**City Planning Commission  
Meeting – February 24, 2015**

**CONSIDERATION – SUBDIVISION DOCKET 162/14  
Applicant: Esplanade Nola, LLC**

**Prepared By:** Stephen Kroll

A Resubdivision of Pt. Lot 9, per Assmt. Roll & Pt. Lot 9 Into Lot 9X.

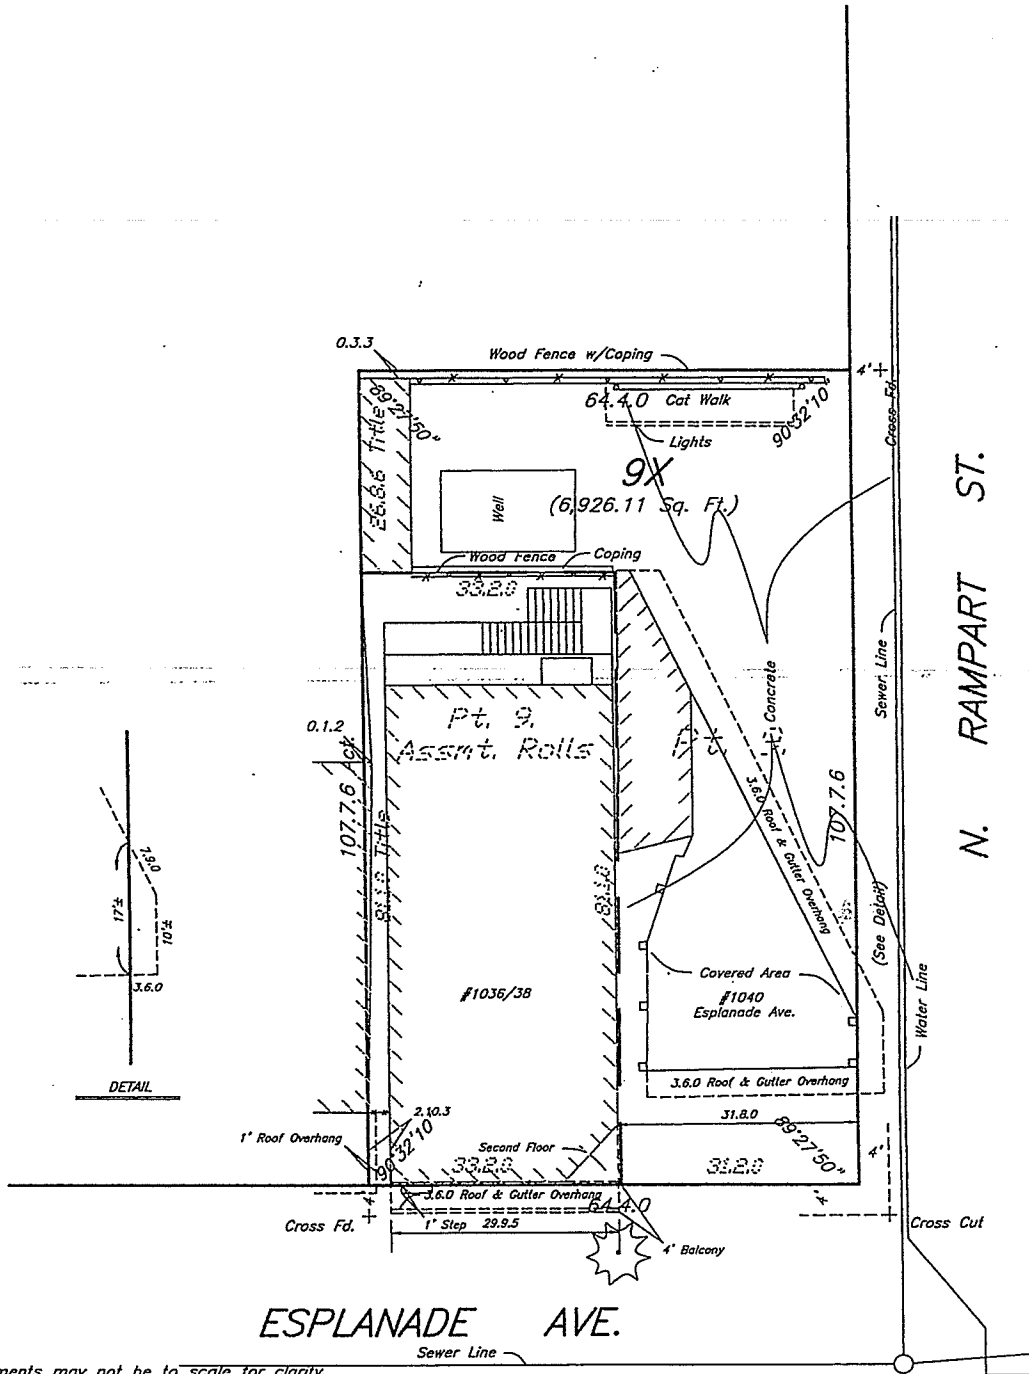
The proposed lot is compliant with the applicable lot width, depth, and area standards in the Comprehensive Zoning Ordinance. In accordance with **Article 8, Section 8.5.7** and **Table 8.D** of the Comprehensive Zoning Ordinance, there are no minimum or maximum lot width or lot depth requirements for any lot in a VCC-2 Vieux Carré Commercial District. There is no minimum or maximum lot area requirement for commercial uses. There is a minimum lot area requirement for residential units based on the number of dwelling units. For one unit buildings such as the proposed building, there is a minimum lot area requirement of 1,500 square feet. The 6,926.11 square foot proposed lot would exceed this minimum lot area requirement.

② 2ND FLOOR - LIFE SAFETY PLAN  
1/8" = 1'-0"

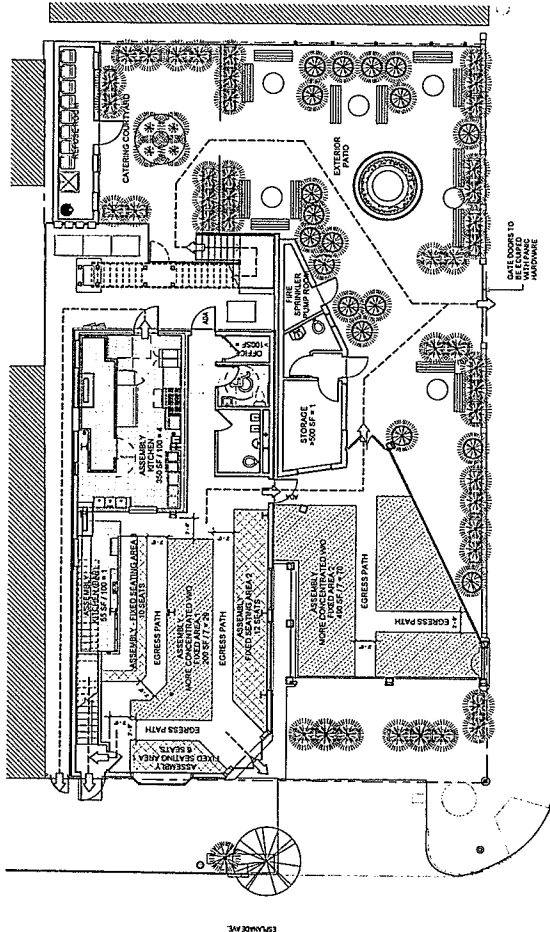
The definition of "net floor area" is defined in NFPA 101 under Ch. 3, Definitions, 3.3.21.2 Area, 3.3.21.2.2 Net Floor Area does not allow for carved out pathways for exiting as shown in Sheet A1.2 of the architect's drawings. The definition only allows for deductions for columns, hallways, stairs, closets. It is unheard of to claim that there will not be occupants in the egress pathways the architect shows in his drawings, in order to get load below 50 (49.). The requirements for sprinkler system and fire ratings shoot up when there are more than 49 occupants. The only way to hold the occupancy at 49 is to put chairs and tables that seat only 49 on the roof. There are no drawings of any tables and chairs up on the roof. The architect states on Sheet A1.2 that an appeal will be filed with the Fire Marshal to claim only 49 occupants, Such an appeal could not be granted without putting tables and chairs up there to limit the standing room aspect. We can't imagine this being practical.
